# CAMBRIDGE/LEXINGTON HOMEOWNER'S ASSOCIATION

This report notes background information, existing conditions, provides an analysis and makes recommendations concerning drainage patterns for two areas in the Lexington Addition. These two areas show conditions of poor drainage due to slow runoff and ponding of drainage water. In effect, these conditions have created tension among impacted neighbors and "finger pointing" as to who is responsible for the situation.

**RE: Backyard Drainage Runoff  
November 9, 1999**

**FIGURE A**

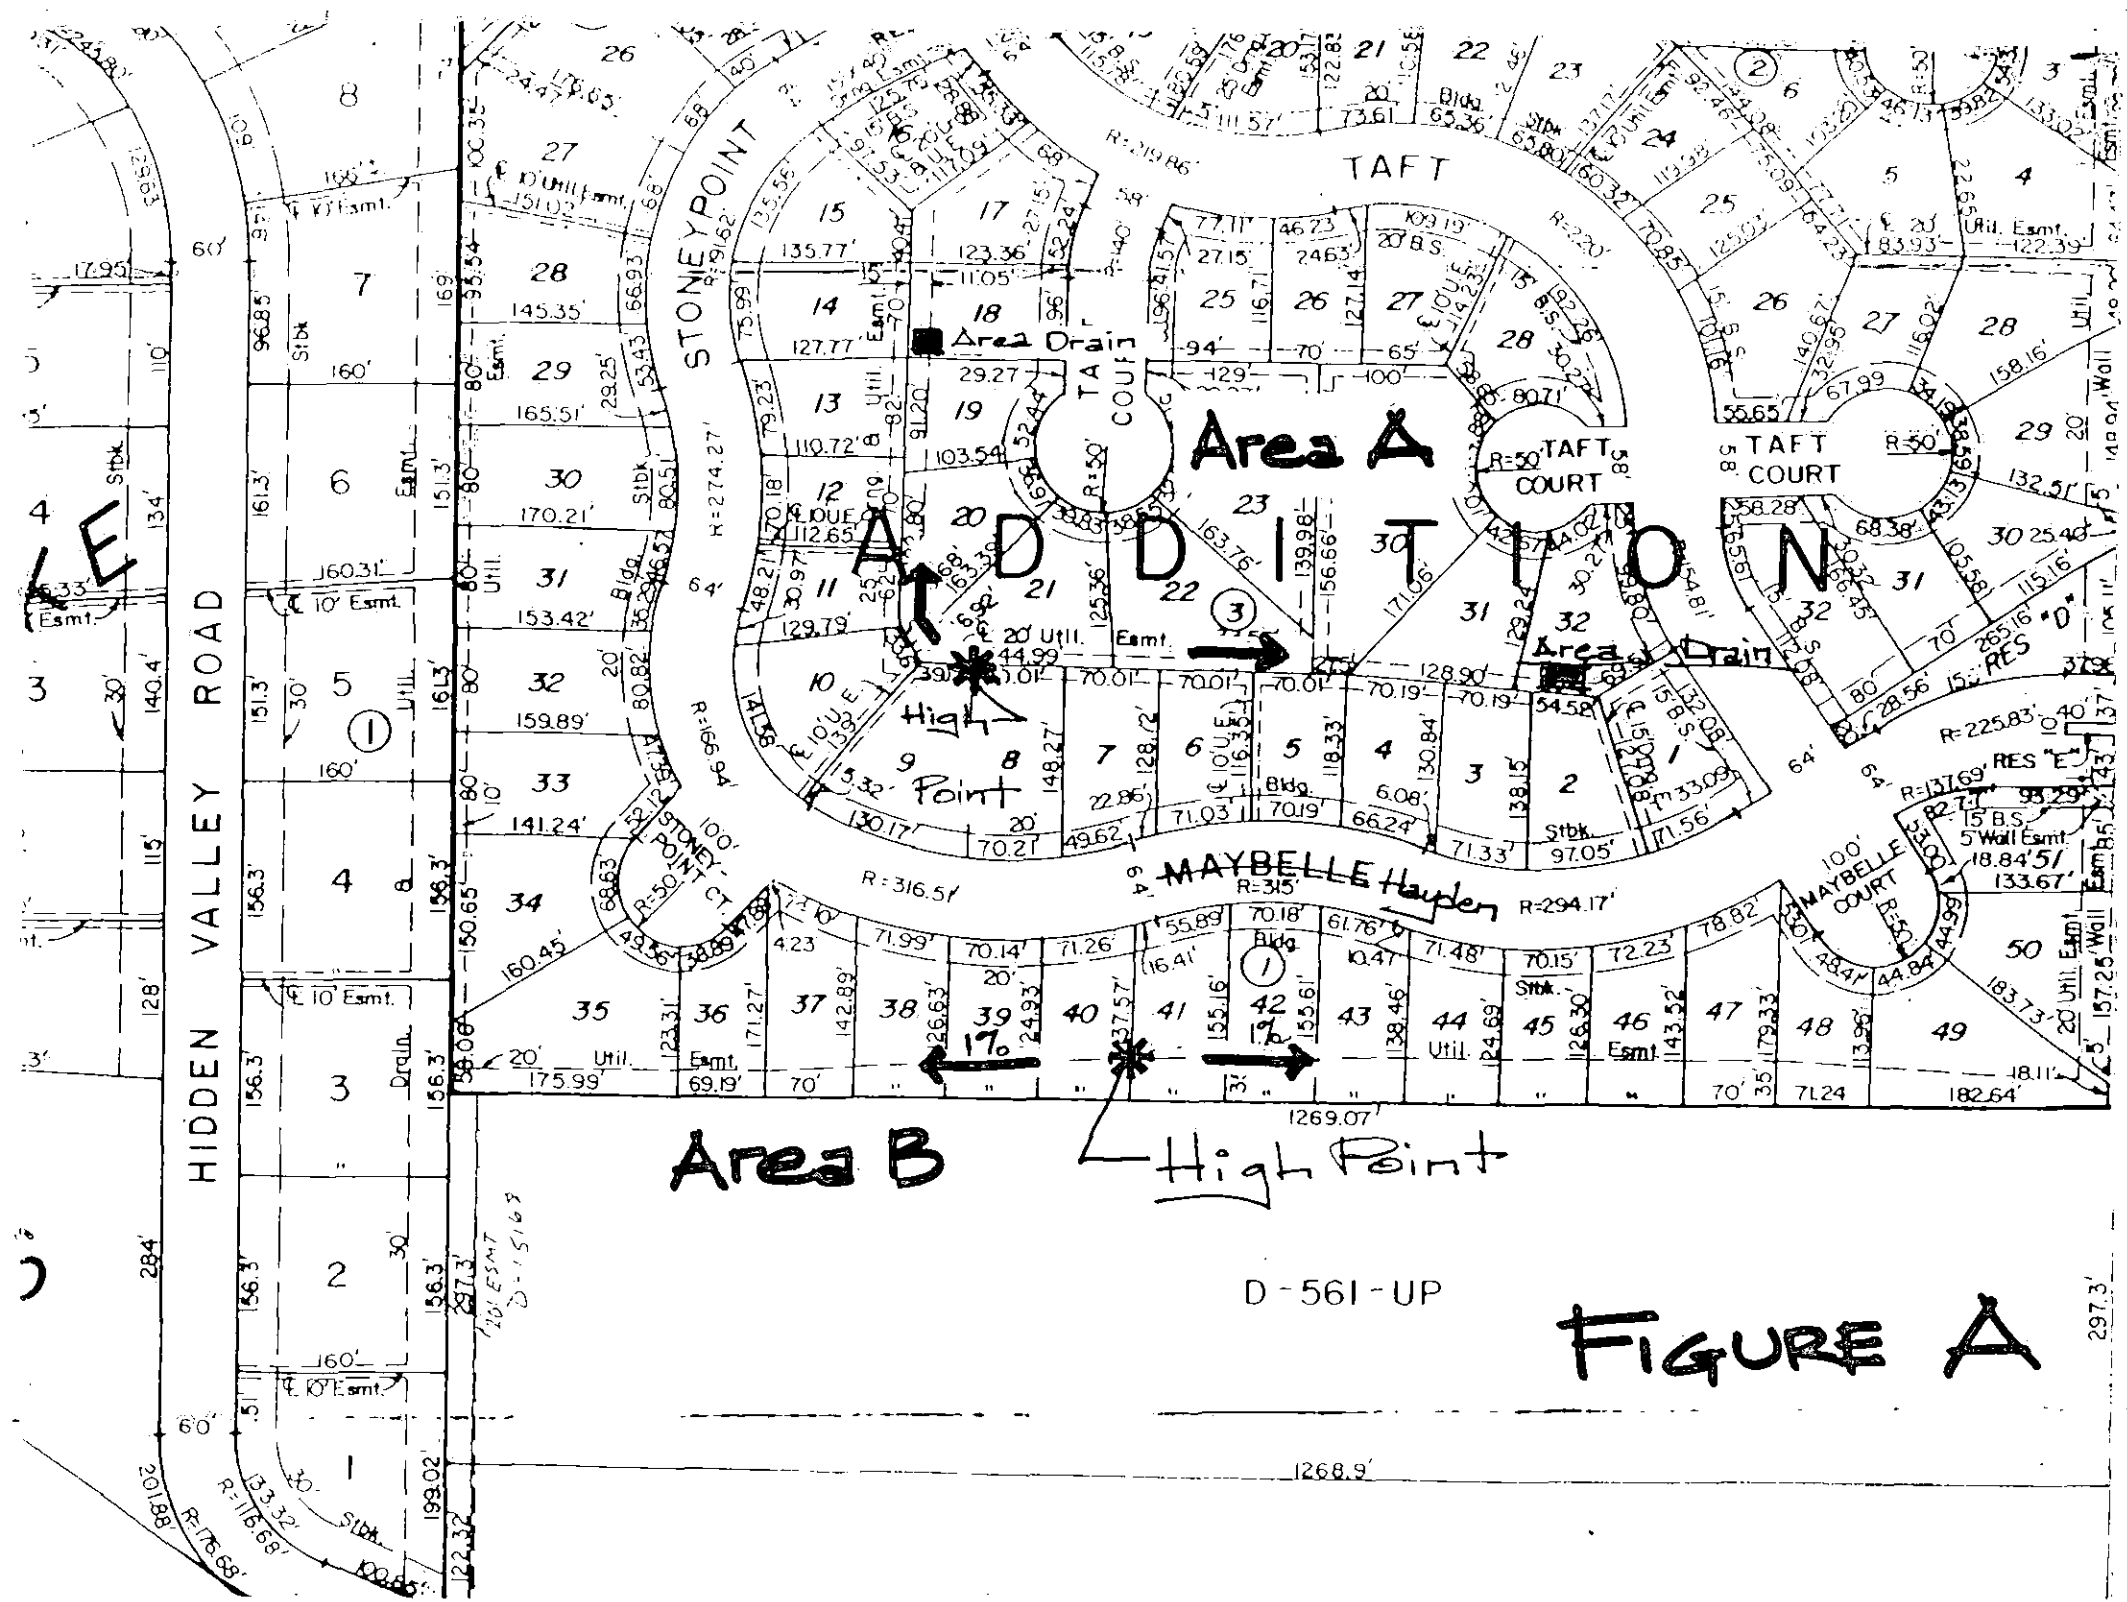
The plat and drainage plans for the Addition were prepared by Poe & Associates, Civil Engineers of Wichita. For Area A, the drainage plan exhibits a high point between lots 8 and 9. From the northwest corner of lot 8, drainage is designed to flow east at a 1% slope to an area drain at the rear of lot 32. Running northwesterly then north from the high point the drainage is designed to flow at a 1% slope to an area drain at the southwest corner of lot 18. For Area B, the drainage plan exhibits a high point between lots 40 and 41. Drainage flows east and west in a swale along the easement line north of the south property line. A 1% slope is designed for lots 36 thru 46 and lots 47 and 48 are slightly less at 0.85% and .84% respectively. At the time of original development, the drainage plan was designed to meet current City regulations. Recent revisions to the City's subdivision regulations require a 1% minimum slope for drainage runoff. Figure A shows the planned pattern of the drainage plan for these two areas.

**FIGURE B**

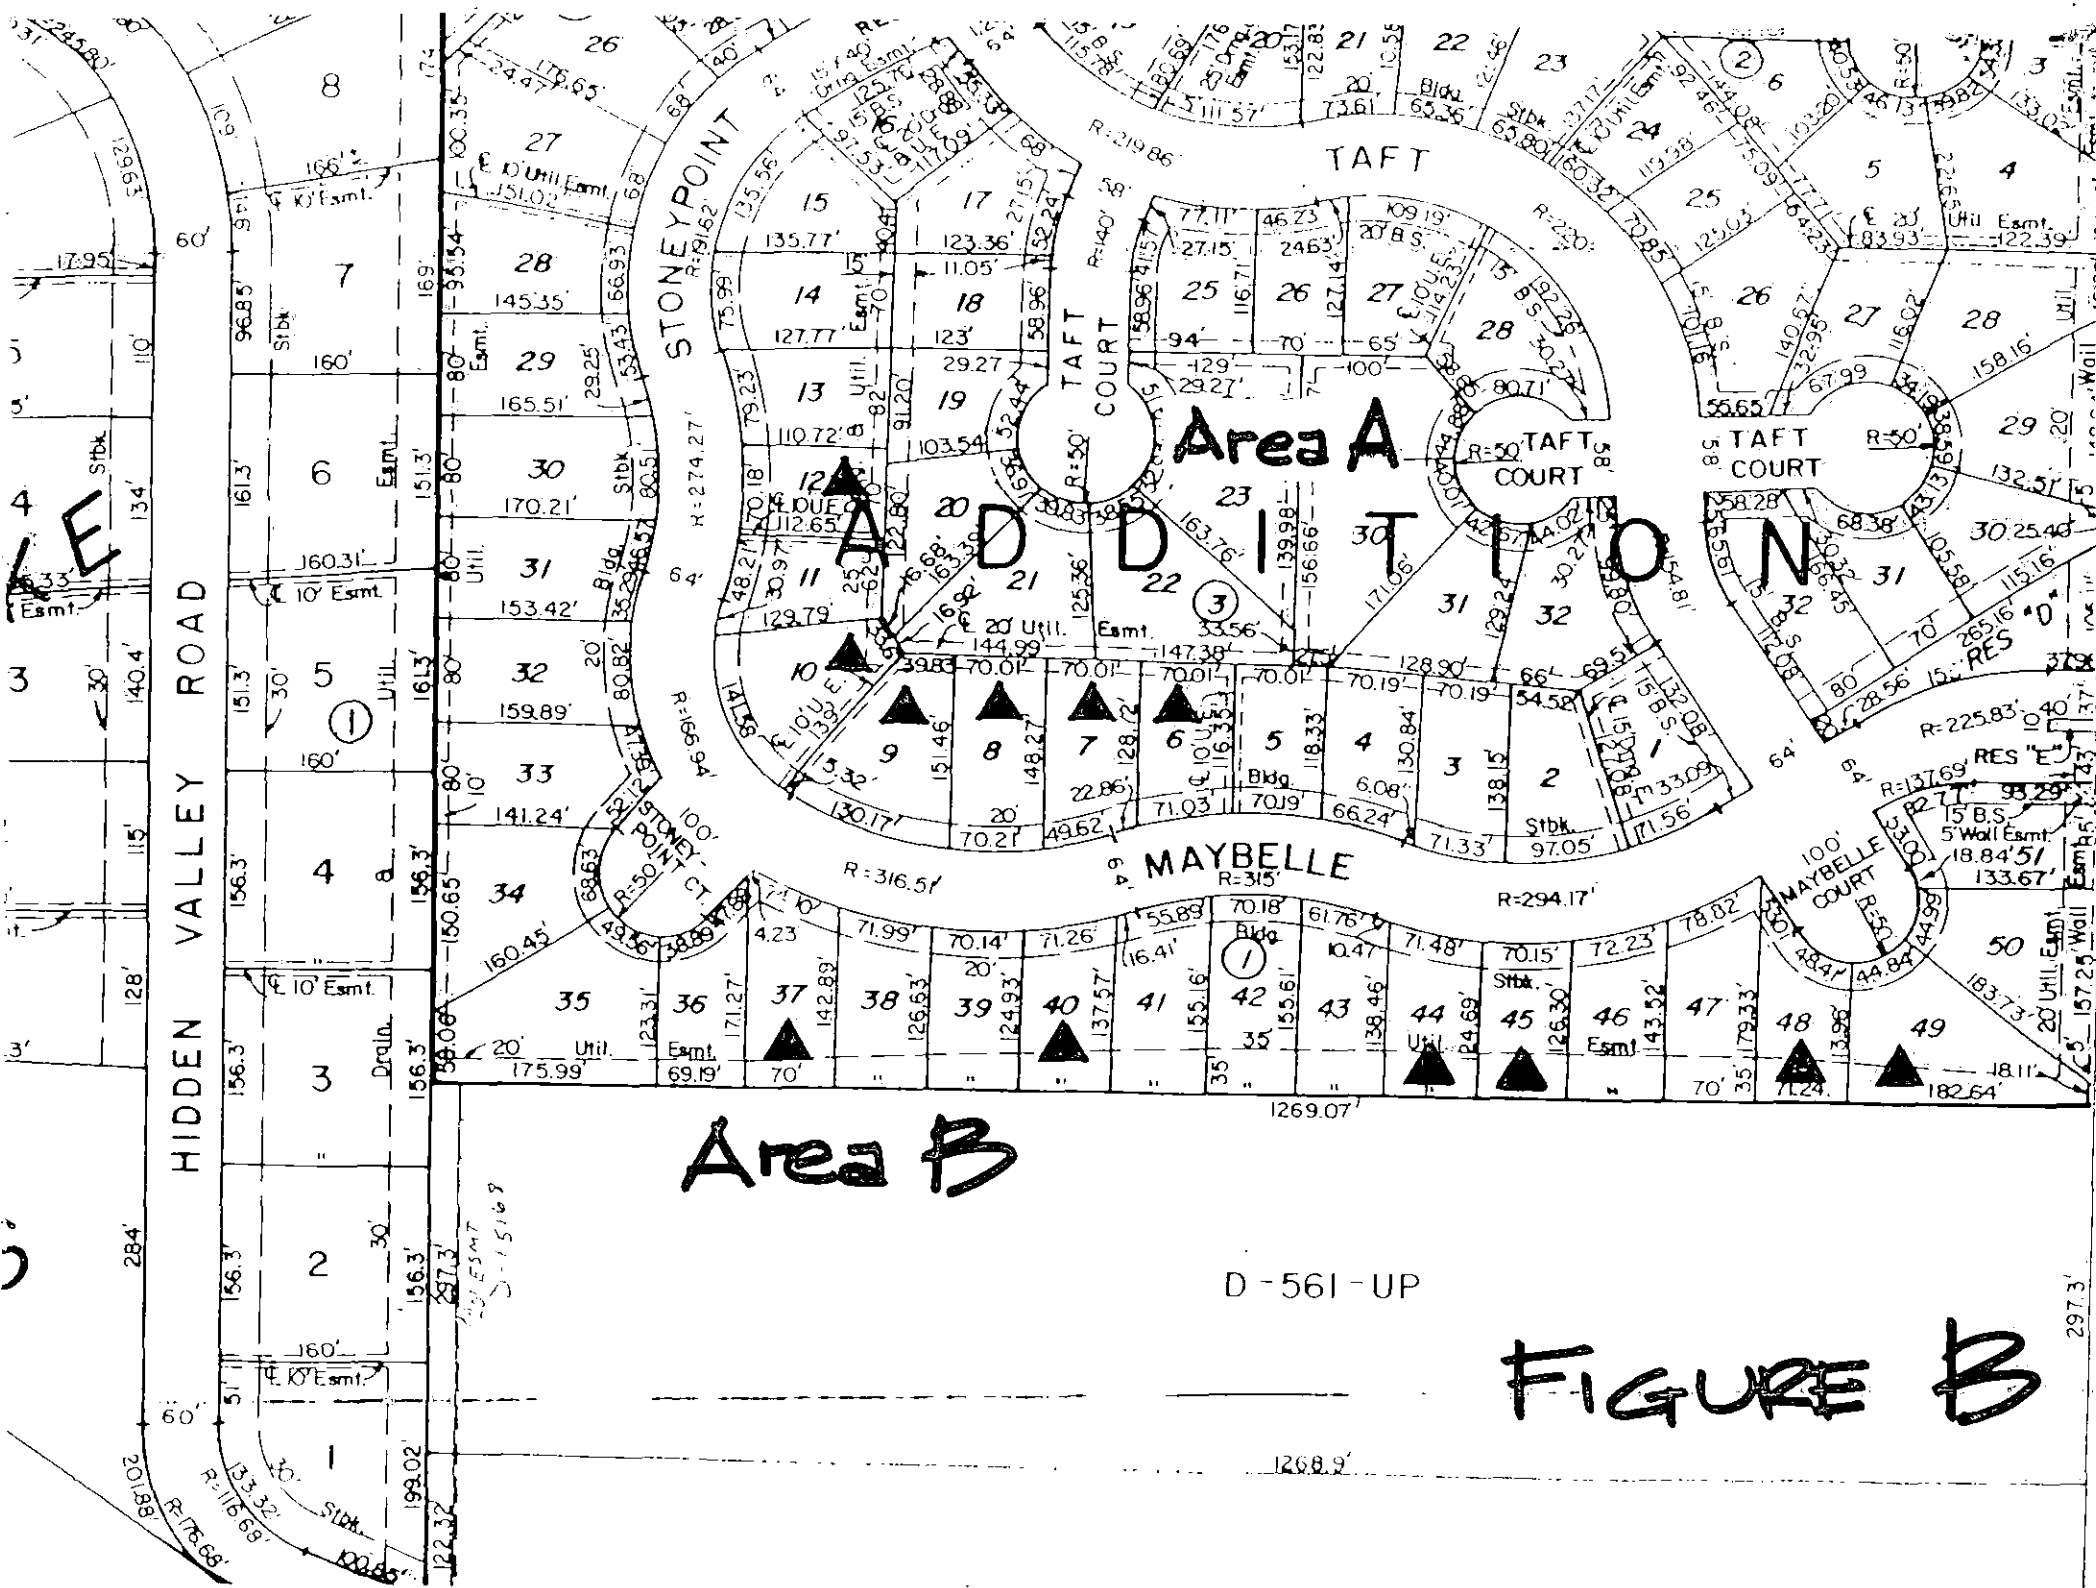
The varied slopes shown in the existing conditions indicates there are drainage problems. Most slopes less than 1.0 % and several flat areas will cause slow drainage and ponding. If the slopes are studied between existing conditions and the planned drainage it is possible to examine the problem more broadly. For area A, from the high point northward to the area drain on lot 18 there would be a 0.93 % if existing conditions in between were not considered. This is close to the planned drainage. Going east from the high point the drainage is only at 0.62% to the northeast corner of lot 5. Note that the grade shot there was taken at the general low point along the fence which would be the drainage flow once the soil is removed from the bottom of the fence. Further grade shots would need to be taken to relate to the area drain to the east.

For area B, from the high point west to the southwest corner of lot 37 the slope is 0.67%. If the slope is taken from the existing elevation at the southwest corner of lot 40 west to the same corner of lot 37 the slope increases to 1.05%. From the southwest corner of lot 44 to the southeast corner of lot 47 the slope is 1.02%. Further analysis such as this along with the sequence of grading work for lots could be done to understand why 1.0% grades were not achieved uniformly as planned. This would not be practical now because improvements exist which limit the possibility of going back and regrading the subdivision throughout all of these problem areas.

While it would be ideal to regrade the problem areas to conform to the drainage plan it is not practical due to the improvements along rear lot lines made by homeowners. These improvements include grass, irrigation systems, swimming pools, fences and ornamental landscaping. It is important to note that all of these improvements were made by homeowners following grading and drainage work established by the builder. Due to the improvements in place, it is recommended that a system of area drains and French drains be implemented to solve the drainage problems of all lots which stand water after rains or irrigation use and have slope gradients of less than 1%. Figure B exhibits these lots. This work will require minor regrading and repairs to irrigation systems, lawn areas and perhaps damaged utility lines. To avoid adverse impact to adjacent lots by dumping drainage water from effected lots, it is recommended that underground drain pipes be extended to the area drains in place. Slopes of 2% minimum are recommended for regrading to new area drains and French drains on lots.
